UNITED STATES PATENT AND TRADEMARK OFFICE

Office Action Summary	Application No. 10/534,690	Applicant(s) OCHI ET AL.	
	Examiner DNYANESH KASTURE	Art Unit 4147

DETAILED ACTION***Specification***

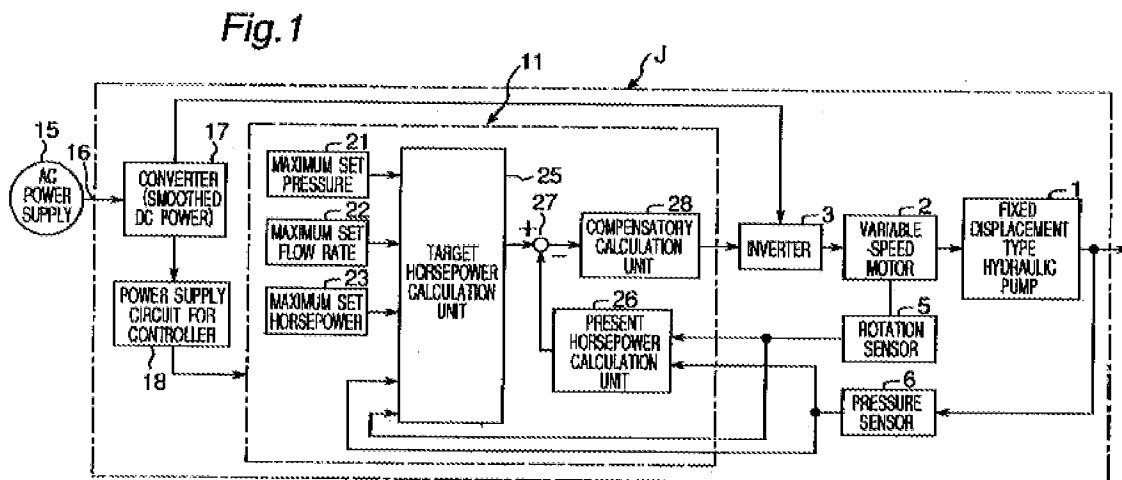
22. In Re claim 1, with reference to Figure 1 depicted above, Horiuchi et al discloses a pump driving method comprising:

- driving a motor (2) using a controller (11) based on a horsepower command value using a discharge pressure – discharge flow characteristic (as described on Page 4, Paragraph [0021])

- carrying out feedback control of the discharge pressure using the signal from the pressure sensor (6) (as described in line 3, Page 4, Paragraph [0021])

- driving a pump (1) using motor (2) (as described in line 14, Page 4, Paragraph [0021])
- the pump (1) inherently changes its pressure/flow rate when the AC power source voltage drops due to the lowering of the input horsepower as a result of the drop in power voltage. This condition is temporary until the controller judges which region the present operating state belongs to and acts accordingly to stabilize the pump. If the voltage drop is significant, the controller may not be able to stabilize the pump since the source input horsepower is insufficient to maintain the new state.

23. In Re claim 6, with reference to Figure 1 depicted above, Horiuchi et al discloses a pump driving apparatus comprising:

- a motor (2) configured to be driven based on a command signal from the inverter (3) using a discharge pressure - discharge flow characteristic (Page 3, Paragraph [0019], line 9)
- to feedback control (27) a discharge pressure (6)

- a pump (1) operatively coupled to motor (2)
- a characteristic changing section (21), (22) where the maximum pressure and flow rate can be changed. Also, the microcomputer element of the characteristic changing section is inherently capable of calculating a new pressure - flow rate characteristic as a programmed function of power voltage input value.

24. In Re claim 9, with reference to Figure 1 depicted above, Horiuchi et al discloses :

- a motor (2) configured to be driven based on a command signal from the inverter (3) using a discharge pressure - discharge flow characteristic (Page 3, Paragraph [0019], line 9) to feedback control (27) a discharge pressure (6)
- a pump (1) operatively coupled to the motor (2)
- an apparatus (11), (21), (22), (23), (25), (27), (28) that is capable of making changes to the control algorithm if necessary, only when the system is stable.
